***Interactive comment on “Linking baseflow separation and groundwater storage dynamics in an alpine basin (Dammagletscher, Switzerland)” by F. Kobierska et al.***

**F. Kobierska et al.**

Received and published: 12 June 2015

REVIEWER 1 – General comments

**Fig. 1.** Figure 4\_bis

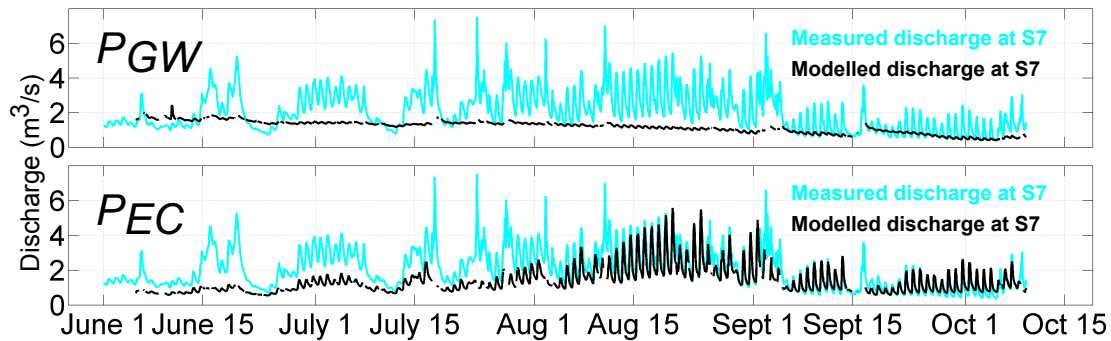
REVIEWER: Page 12202: It would be interesting to see a figure comparing the hydrographs of observed flows versus PEC and PGW.

AUTHORS: Please find attached the figure 4\_bis comparing PEC and PGW with measured discharge. We can see that PEC yields much better results than PGW. For now, we did not integrate those extra figures in the manuscript because we think that the performance values in Table 3 are sufficient and that the interested

reader can also access this response. Figure 4\_bis. Measured and modelled discharge ( $\text{m}^3\text{s}^{-1}$ ) at S7 for the partial models PGW (upper panel) and PEC (lower panel).
